SR 99 AURORA AVENUE BRIDGE FENCE

Design Committee

Work Book

DRAFT

Elevation
Viewed from the traveled way

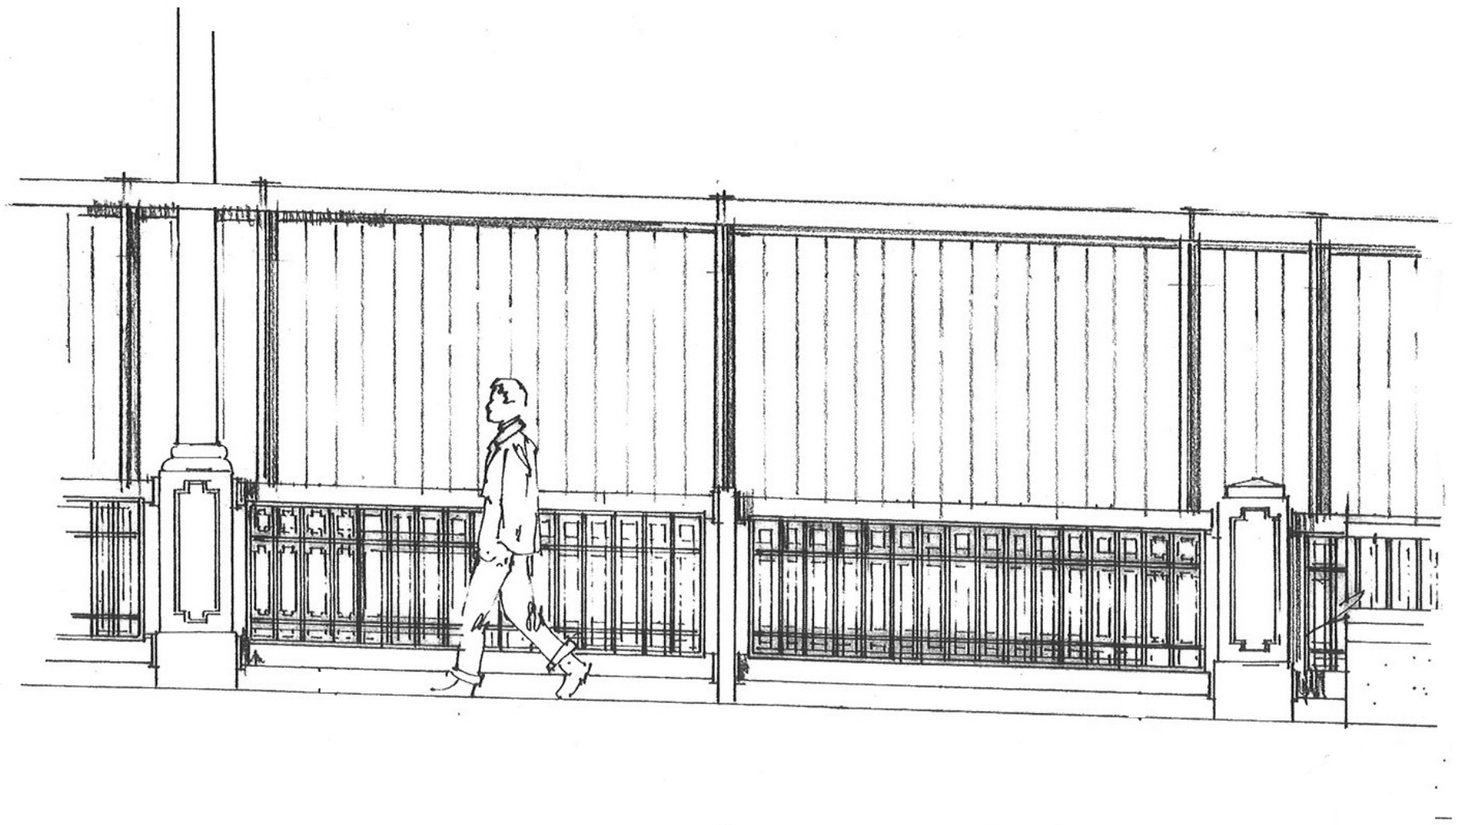
Provide a demountable double T frame system to house 3/16" stainless steel cables. Tension cables to prohibit spreading.

Design an overhang to discourage climbing.

Frame detailing will be visually light to facilitate views.

The fence weight is critical to structural bridge preservation issues.

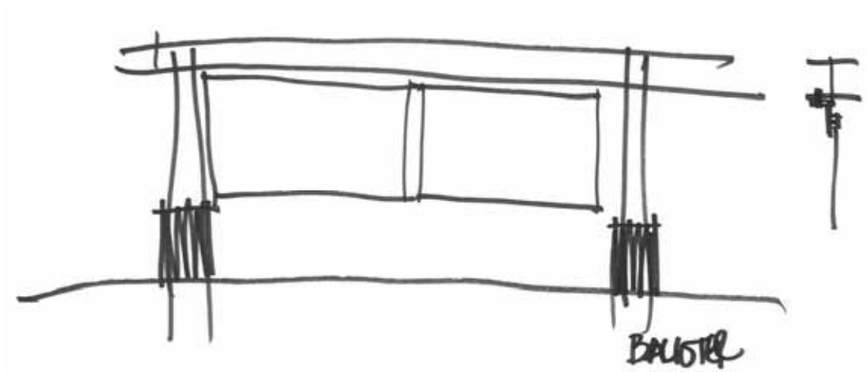
The top frame may span between main rail posts and the cable frame hang from the span.

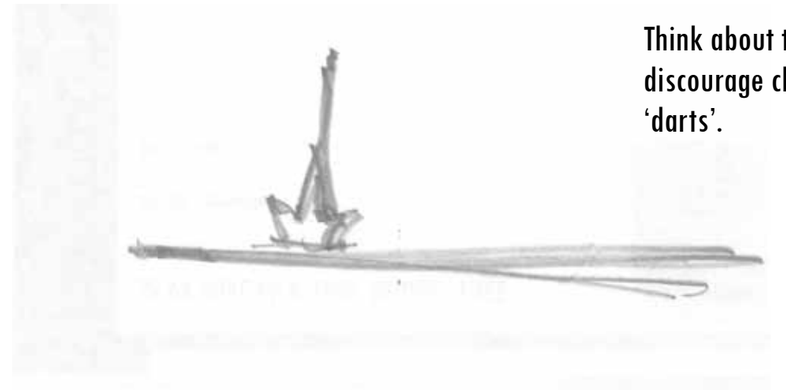
Think about traditional methods to discourage climbing such as fence 'darts'.

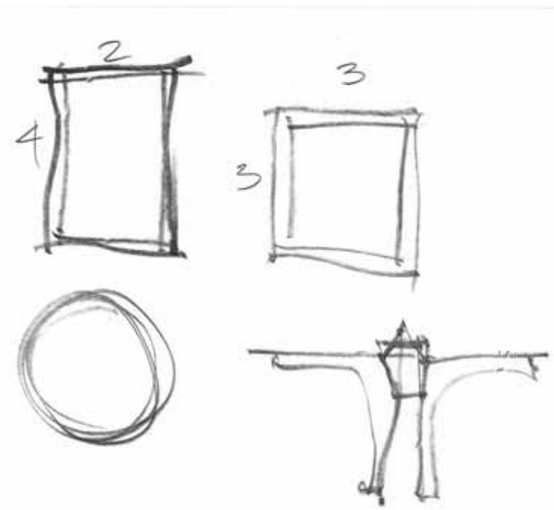
The style of the top frame may be ornamental....however this should be developed as the design progresses.

Sections under consideration for the frame. Look for sections that are visually light and produce interesting shadow lines.

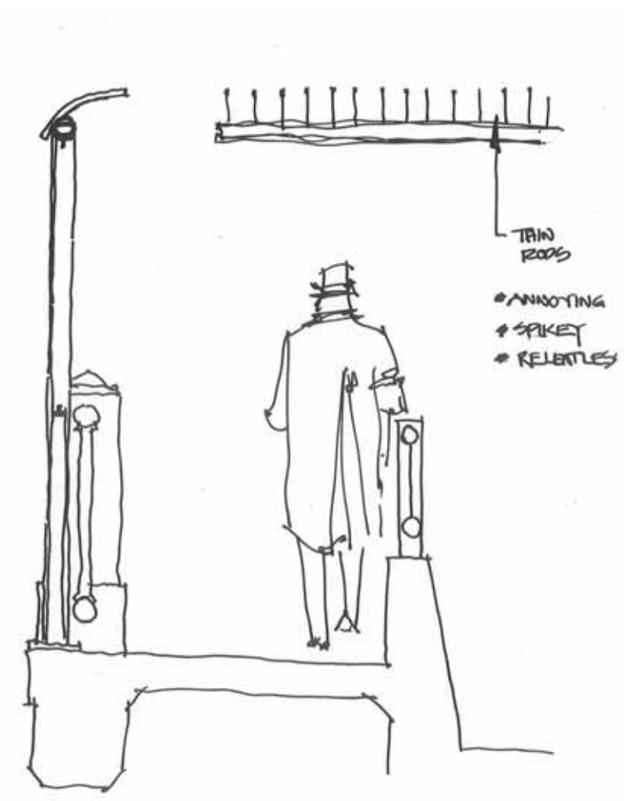
Recommend 'prongs' in lieu of
lidded canopy to discourage
climbing.climb.

Design Concepts:

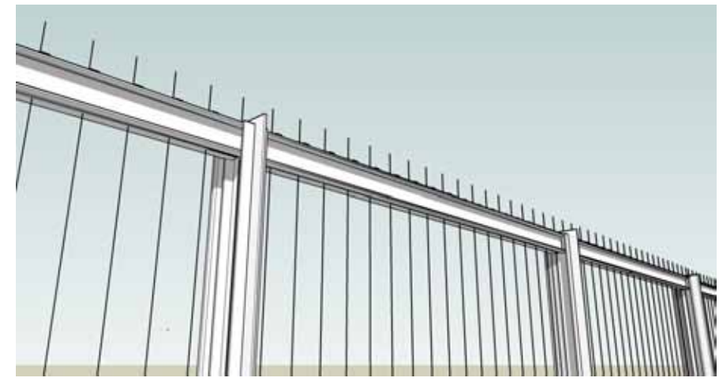
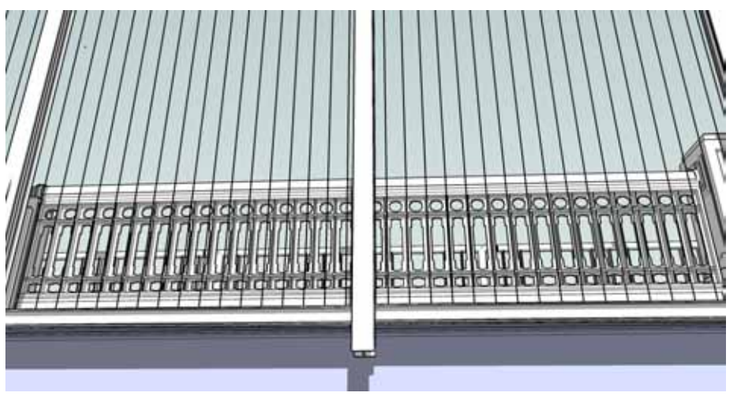
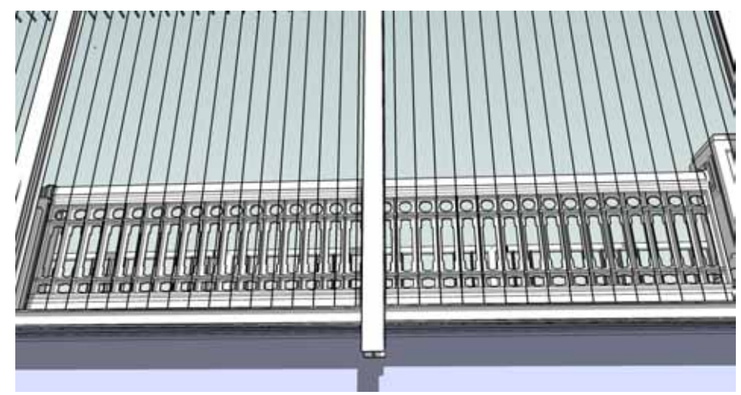
'Channel' sections at the frame top in lieu of 'tubes'. Decrease the size of vertical structural elements to the extent possible.

Extend stainless steel cable vertical elements to bottom of existing railing.
